HITACHI SEMICONDUCTOR TECHNICAL UPDATE

Classification of Production	MCU			No	TN-SH7-402B/E	
THEME	Information about bug with FDIV on SH7055RF		Classification of Information	1. Spec change 2. Supplement of Documents ③ Limitation of Use	4. Change of Mask 5. Change of Production Line	
PRODUCT NAME	SH7055RF	Lot No.	Reference Documents	SH-2E Programming Manual Rev.1.0 ADE-602-178	Rev.	Effective Date
		SH7055RF :ALL lots			2.0	Unlimited

We would like to inform you that there is a bug with FDIV on SH7055RF.

Fig1. Example 1 about bug with FDIV

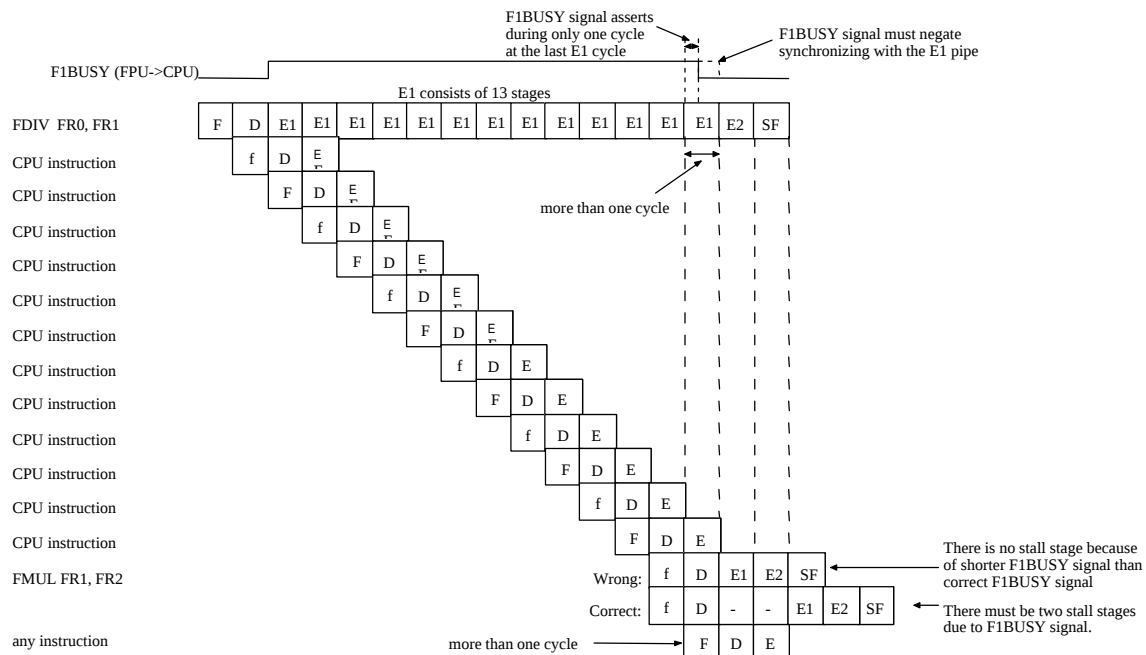
In this example, FDIV operates FR1/FR0 -> FR1, and then FMUL at the 13th instruction after FDIV operates FR1 x FR2 -> FR2. If the number of the fetch cycle of the next instruction of FMUL is more than one cycle, the number of the last E1 cycle of FDIV is extended to more than one cycle due to it. So there is no stall stage in FMUL and FMUL uses the FR1 value before FDIV operation, not the FR1 value after FDIV operation. But FDIV operates itself correctly.

- 1) [The fetch cycle of the next instruction of the FPU instruction is more than one cycle]

Example 1 of Fig 1 is an example of this. There is no this case if the program is located on the internal flash memories and rams.

Fig2. Example 2 about bug with FDIV

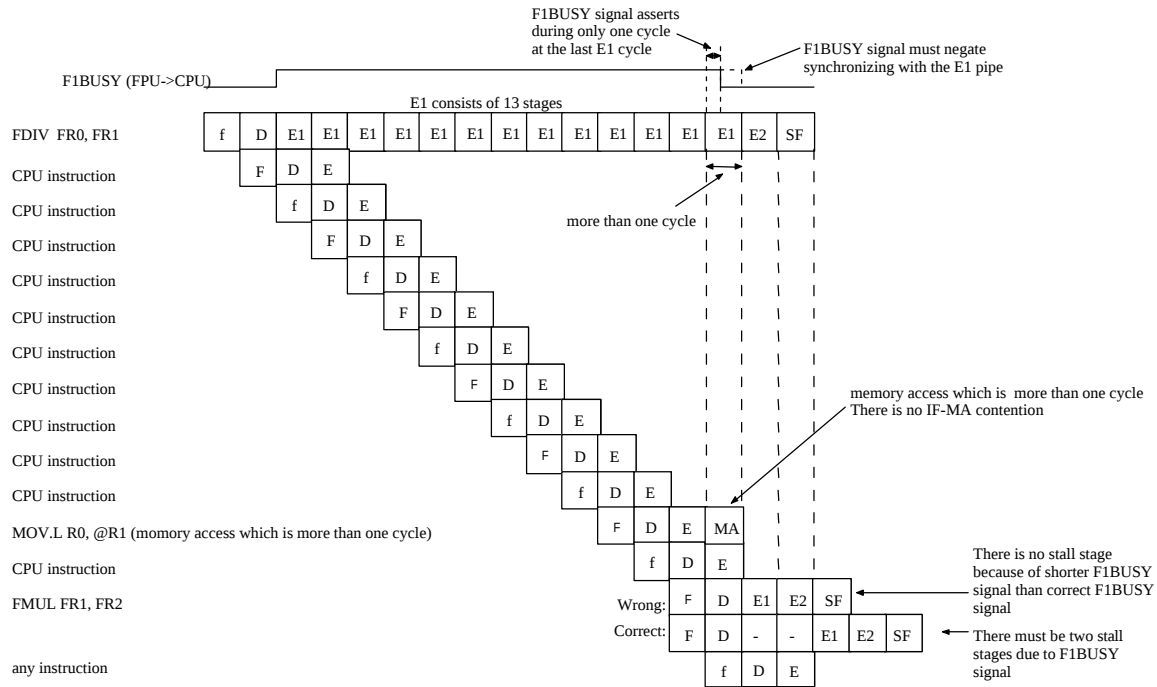
In this example, FDIV operates FR1/FR0 -> FR1, and then FMUL at the 13th instruction after FDIV operates FR1 x FR2 -> FR2. If the 2nd instruction before FMUL operates memory access which is more than one cycle and there is no IF-MA contention at the memory access, the number of the last E1 cycle of FDIV is extended to more than one cycle due to it. So there is no stall stage in FMUL and FMUL uses the FR1 value before FDIV operation, not the FR1 value after FDIV operation. But FDIV operates itself correctly.

- 2) [The last E1 stage of the FDIV overlaps MA stage of more than one cycle and there is no IF-MA contention]

Example 2 of Fig 2 is an example of this. There is no this case if there is no instruction with MA of more than one cycle at one or two instruction before the FPU instruction.
